Chapter 4

REVISIONS TO THE DRAFT ENVIRONMENTAL IMPACT REPORT

This chapter describes and presents revisions made to the Draft Environmental Impact Report (DEIR) for the Estrella Substation and Paso Robles Area Reinforcement Project (Proposed Project). The DEIR was revised based on certain specific comments, as identified in Chapter 3, *Individual Responses to Comments*, as well as to update the document and create the Final Environmental Impact Report (FEIR) and to ensure consistency with changes made in the Recirculated DEIR. All substantive, new revisions to the DEIR are shown in underline/~~strikeout~~ in this chapter and in Volumes 1 (Main Body) and 2 (Appendices) of this FEIR. As described in Chapter 1, *Introduction*, revisions to the DEIR¹ that were previously made as part of the recirculation have been accepted in this FEIR and are not included in this chapter.

Figure 2-1

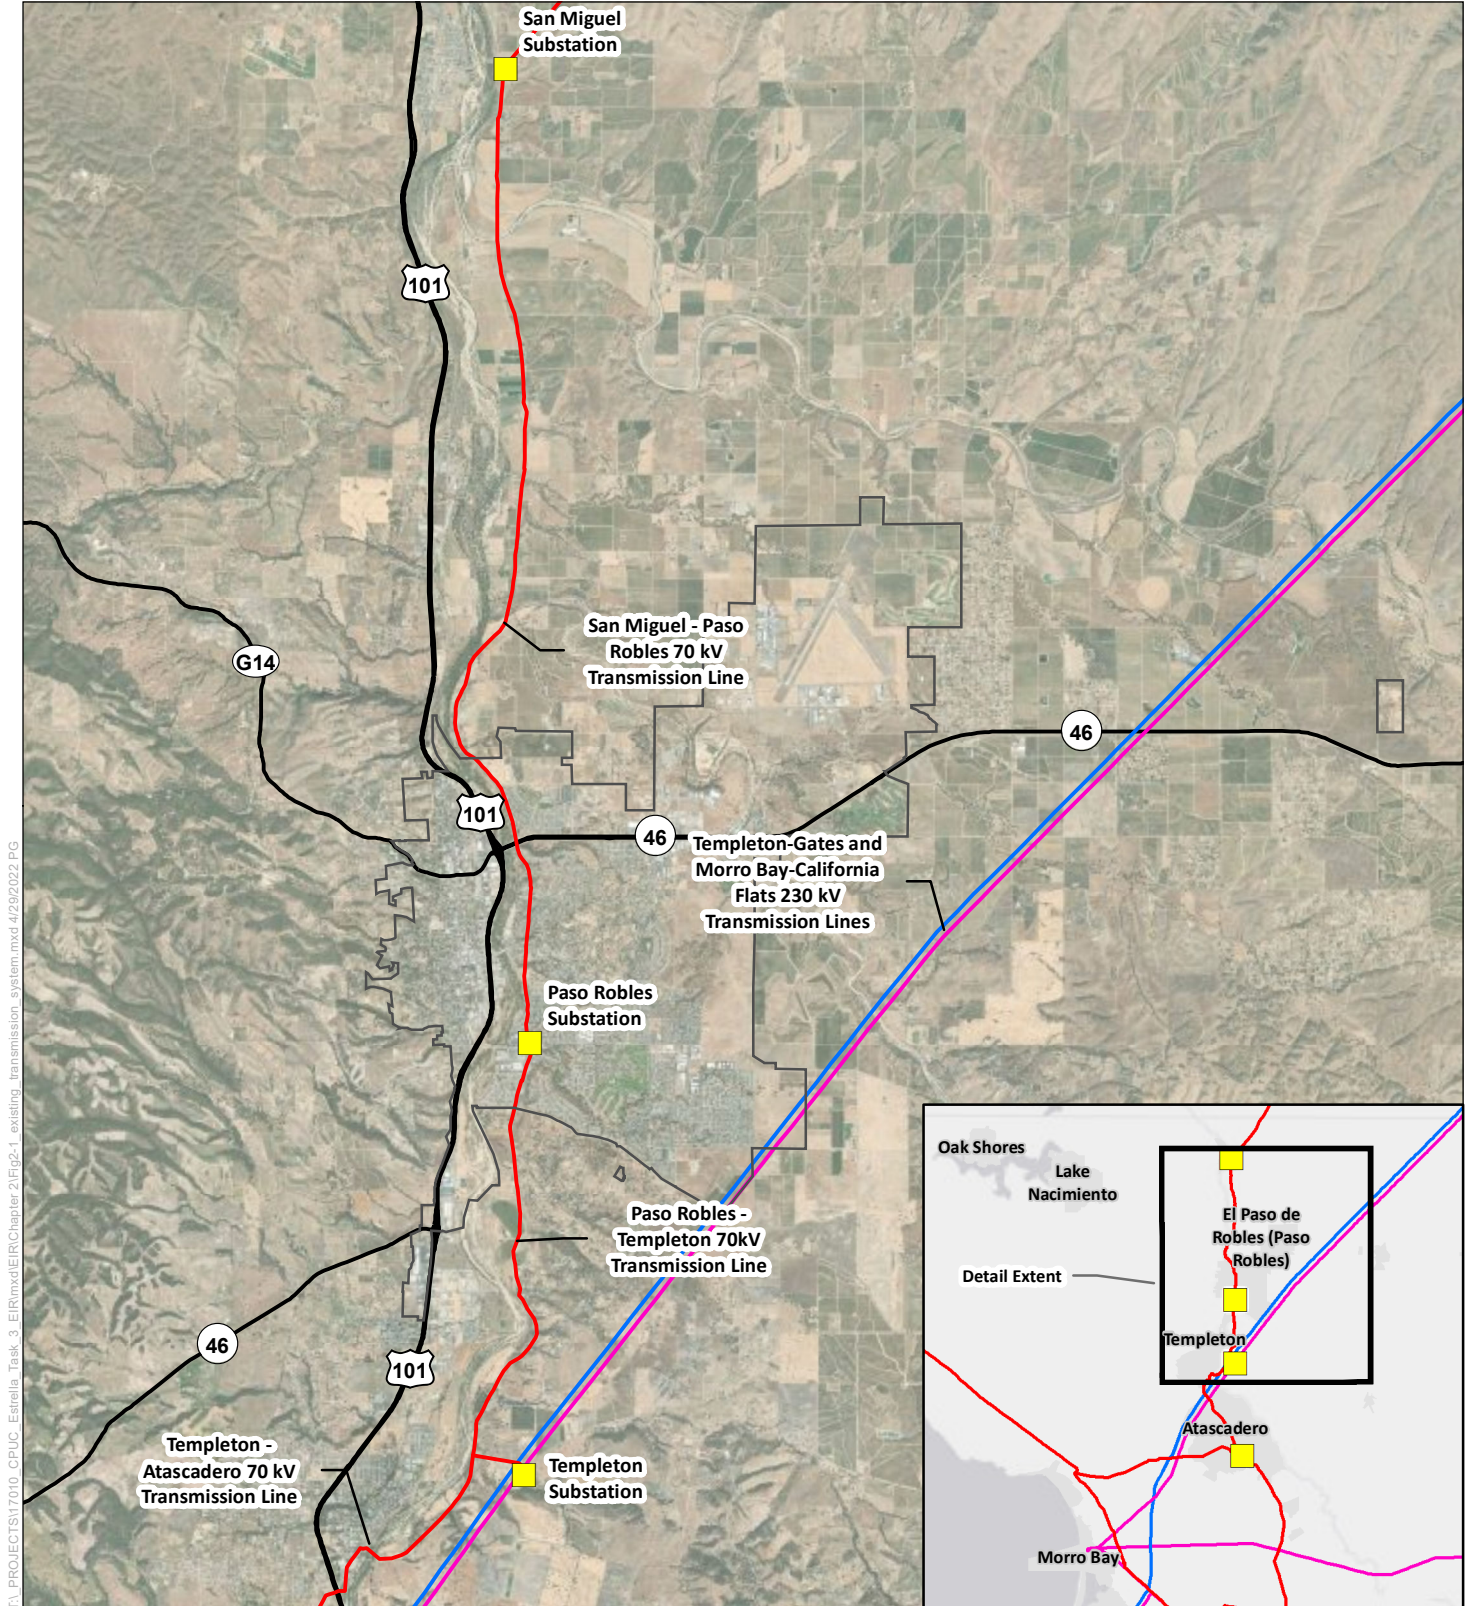
In response to Comment H-61, Figure 2-1 on page 2-4 has been revised to correct the relative position of the 500 kV transmission line that is depicted. The revised figure is shown on the following pages.

Figure 2-4
Existing Distribution System

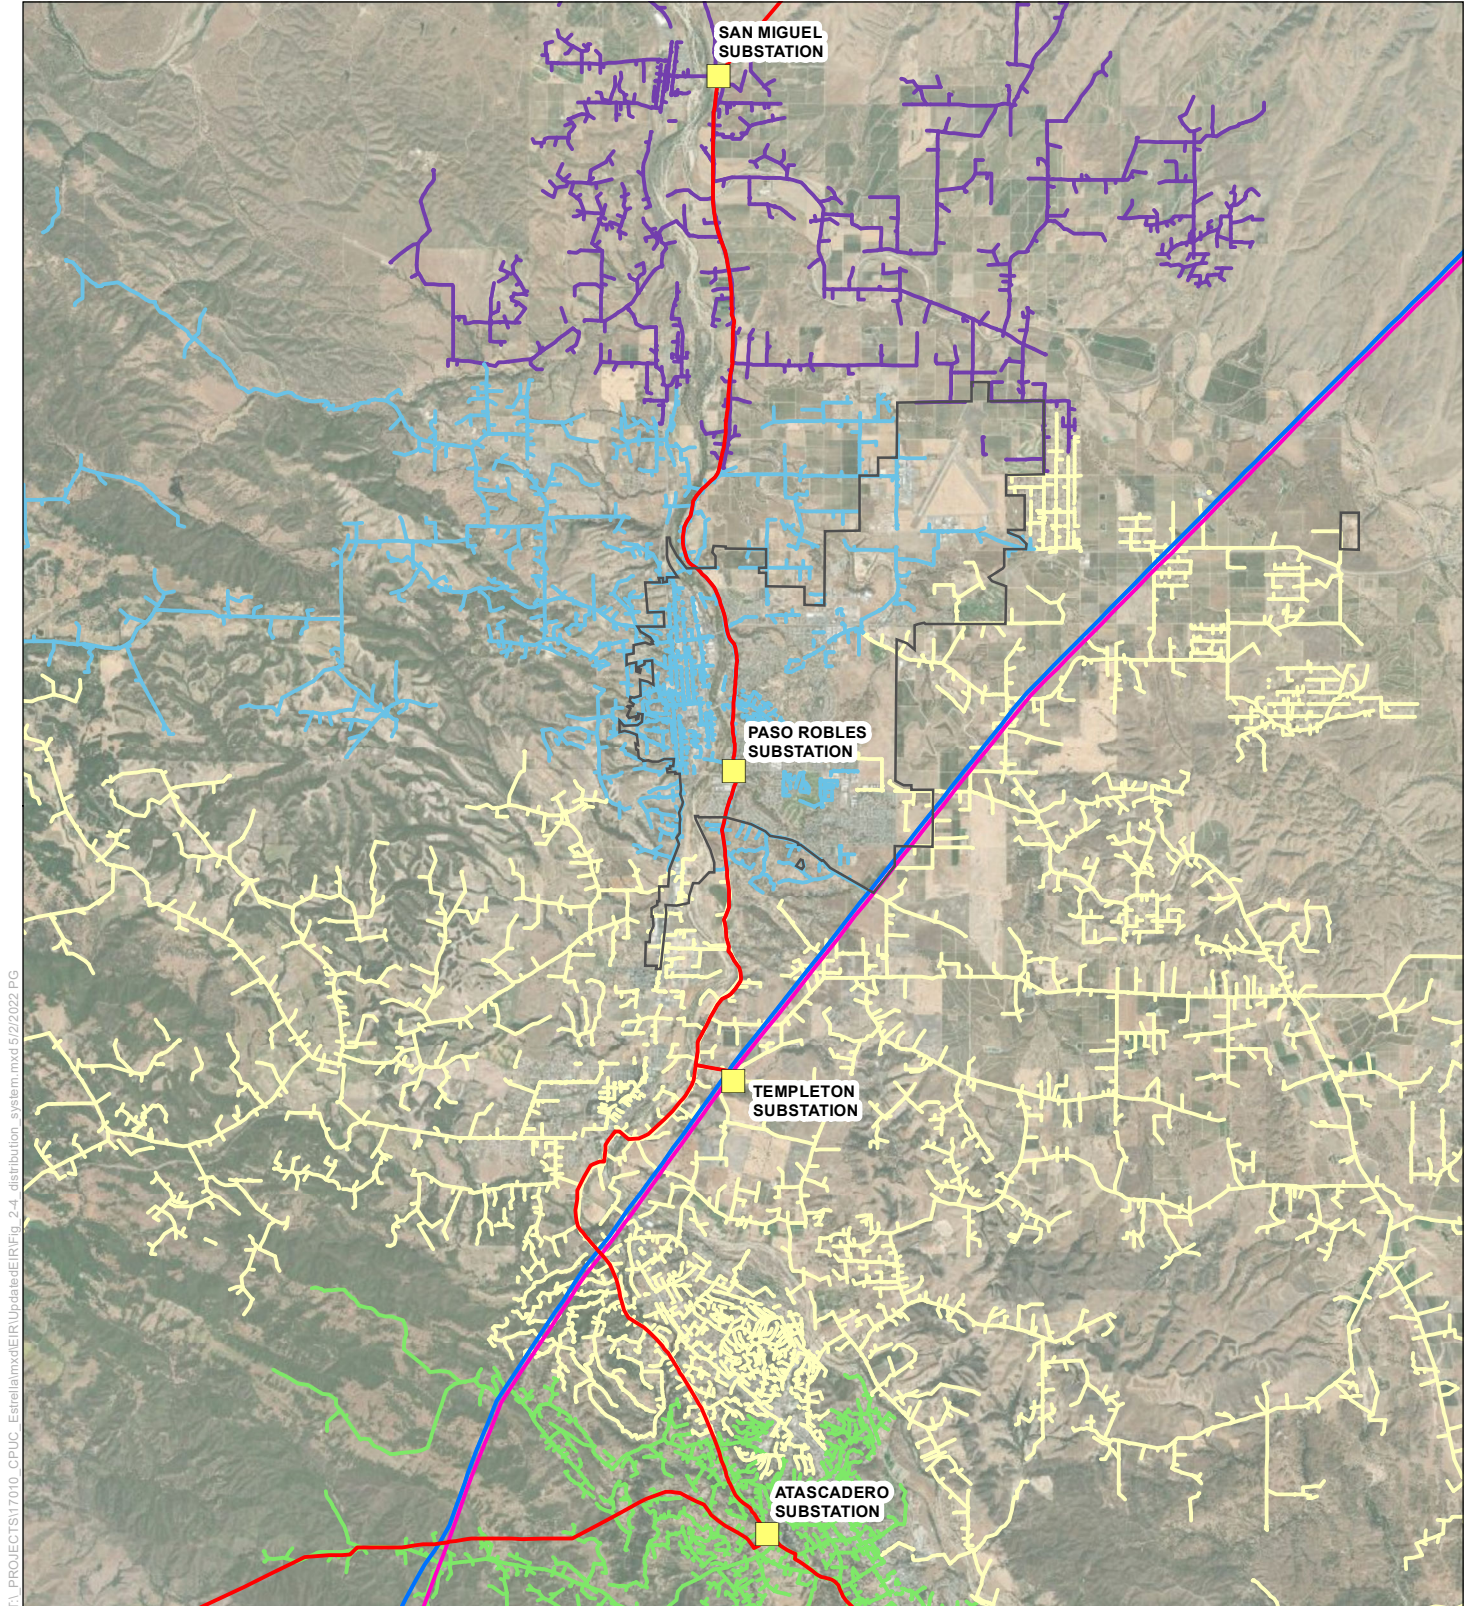
In response to Comment H-65, Figure 2-4 on page 2-7 has been revised to correct the relative position of the 500 kV transmission line that is depicted. The revised figure is shown on the following pages.

Figure 4.4.1
Waters and Wetlands

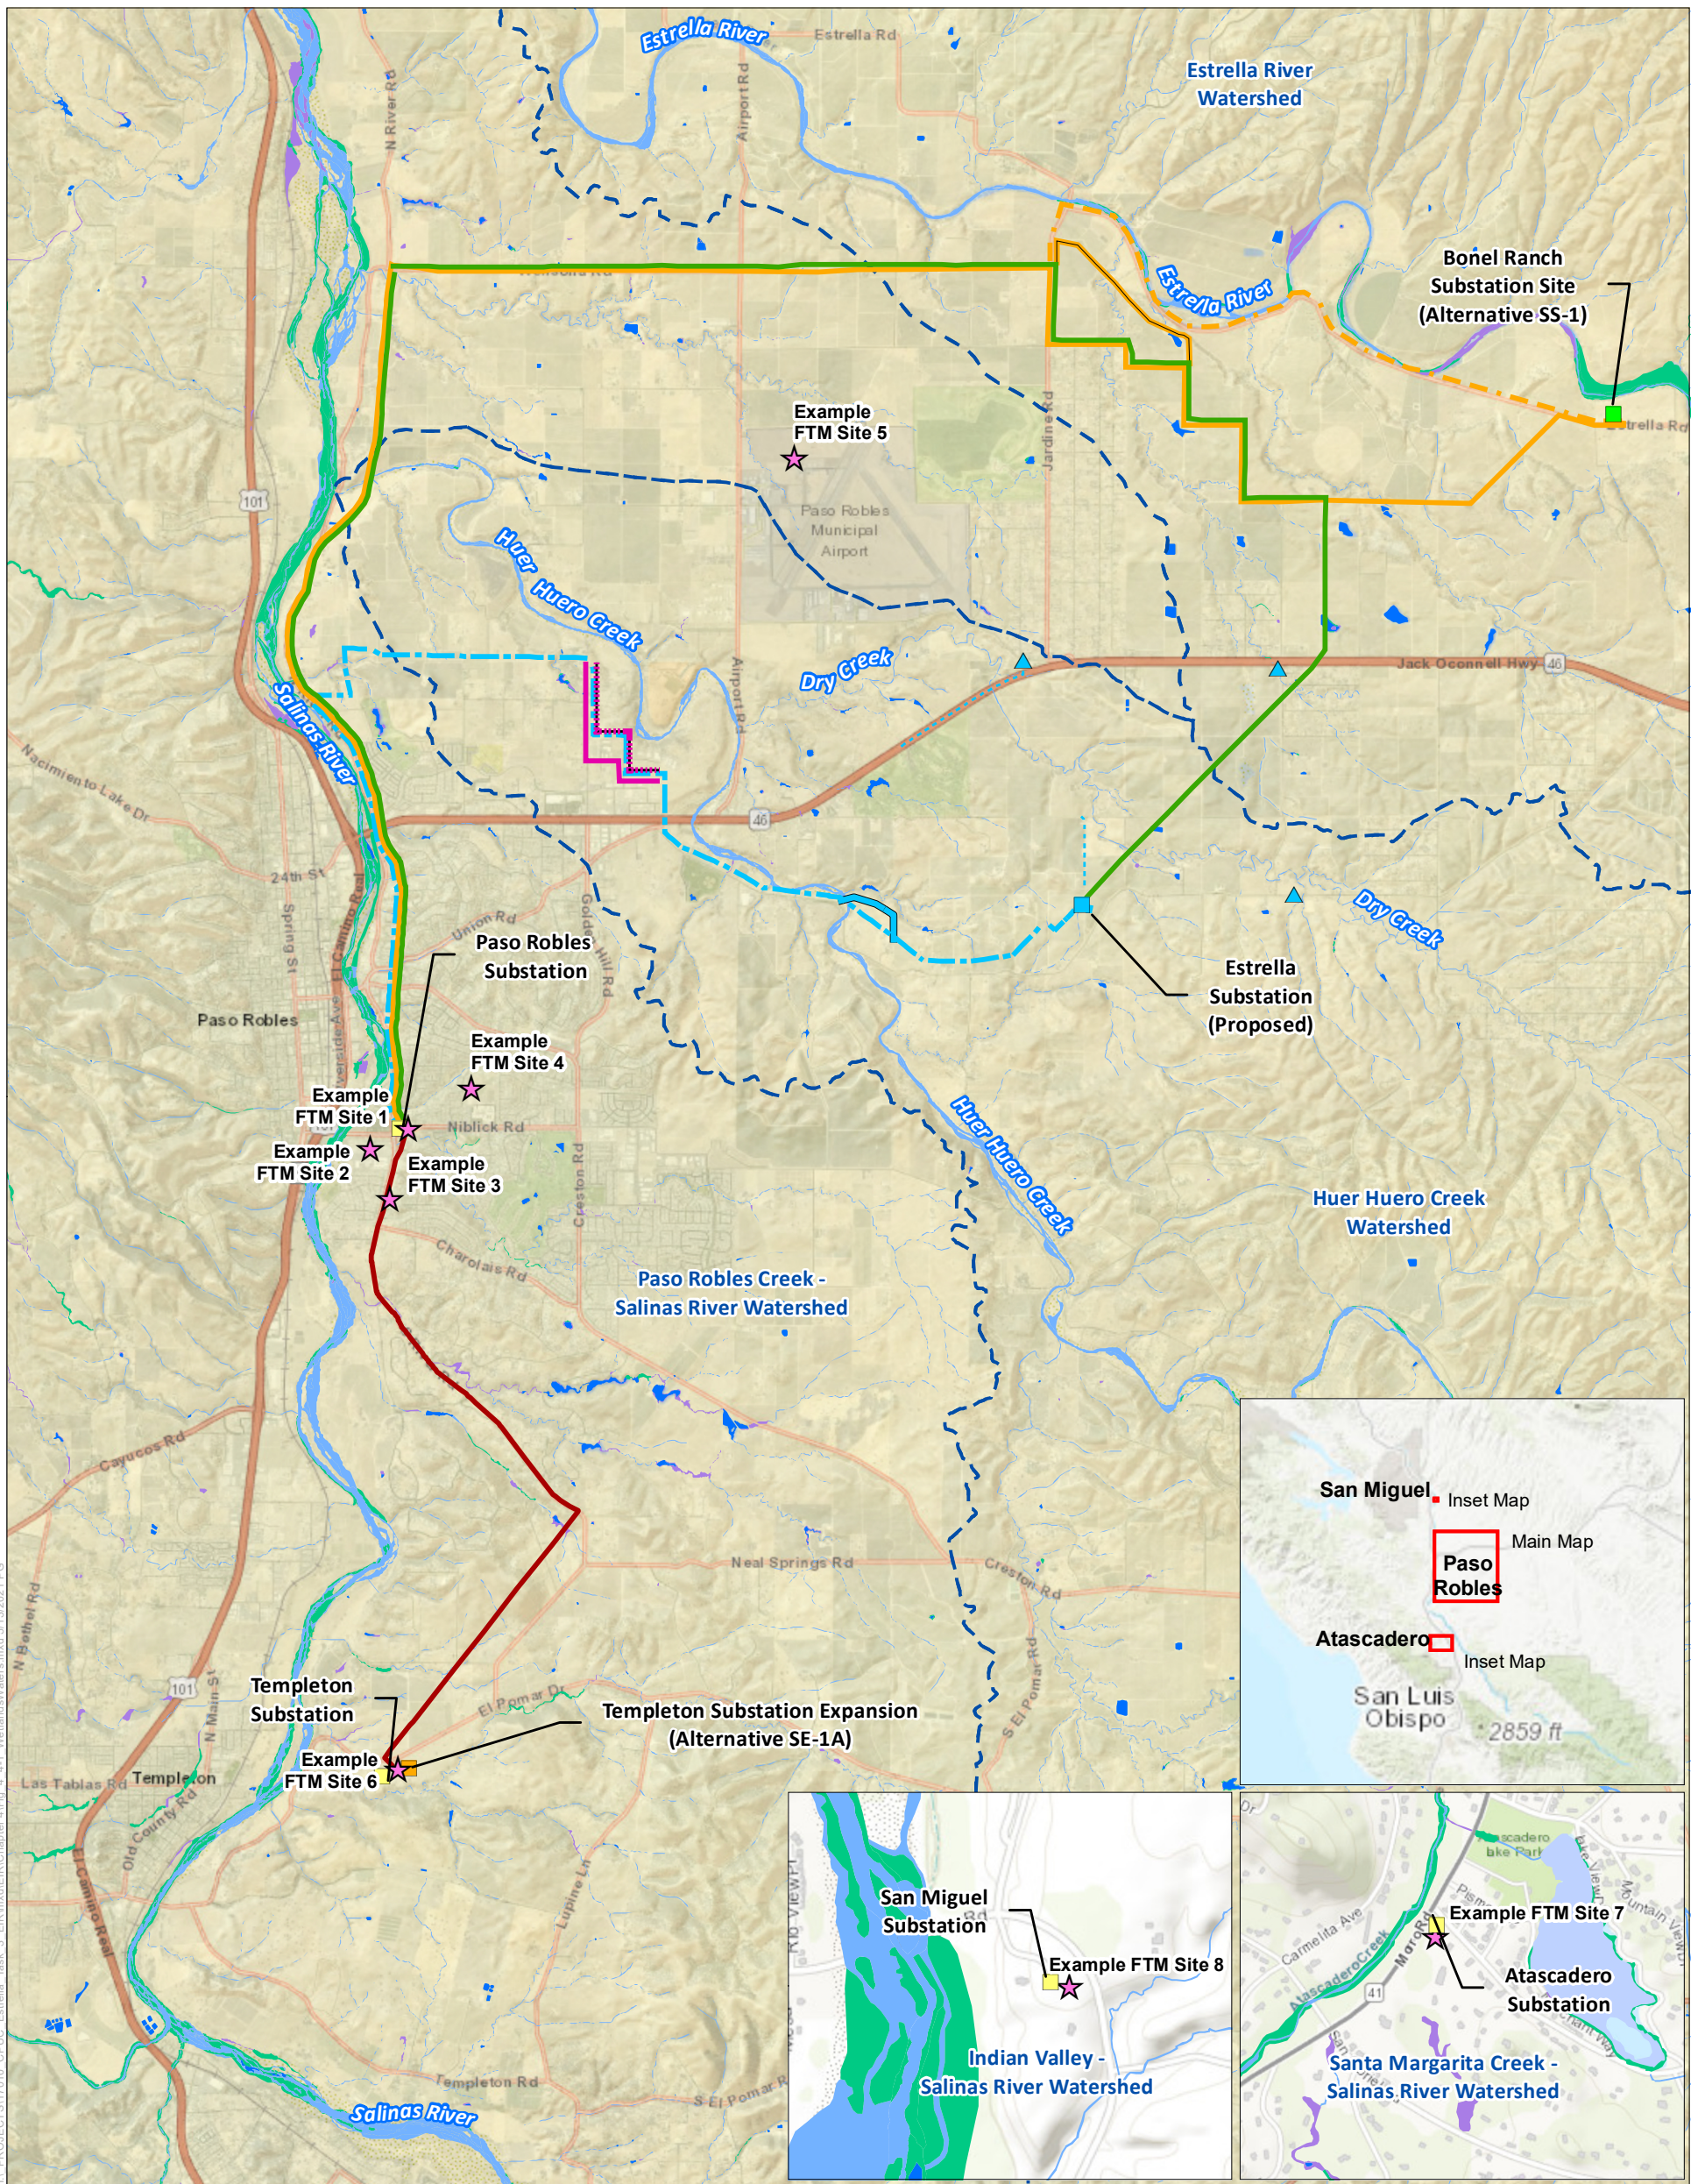
In response to Comment J-137, Figure 4.4-1 on page 4.4-30 has been revised to label the Salinas River and Dry Creek. The revised figure is shown on the following pages.
